# SERVICE BULLETIN

No. 161A

Piper Aircraft Corporation

**SUBJECT:** Fire Hazard

PA-22

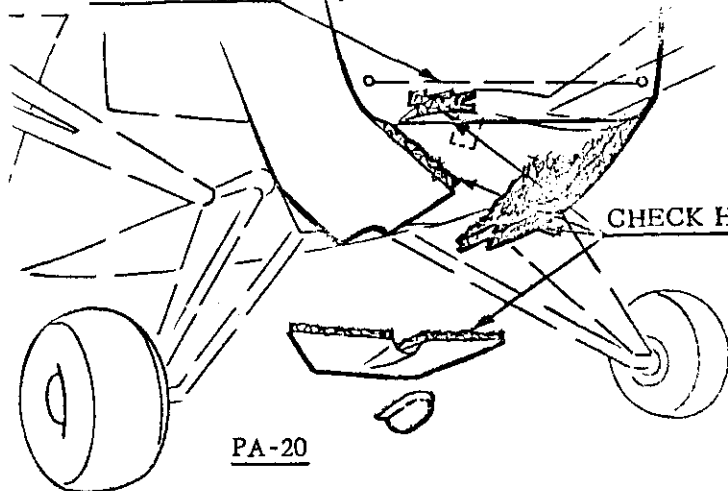
To preclude the possibility of in-flight fires, the following inspection and rework is necessary to eliminate combustible material and possible ignition sources from the area aft of the firewall underneath the forward cabin floor. Access to this section may be gained by removing the metal panels or opening the fuselage side cowl panels rearward of the firewall underneath the aircraft as shown in sketches on reverse side.

Remove and/or open panels as above. Remove and discard any sound-proofing material contaminated with engine or hydraulic oil or any sound-proofing which has the plastic septum separated from the fiberglas or showing signs of drying or cracking. Replacement of a discarded blanket may be made with equivalent fiberglas. Inspect for chafing of wire insulation and replace any inferior electrical wiring. Check for reasonable clearance between hydraulic lines, electrical wires, control cables and fuel lines and provide clearance if necessary.

3. Upon completion of the above, apply a sufficient quantity of B. F. Goodrich non-hardening putty No. 21 or other acceptable aircraft materials between firewall and fuselage cowl blanket to assure an airtight seal when reassembling the opened and removed panels. Non-hardening sealing material is available through your distributor or local aviation supply house.
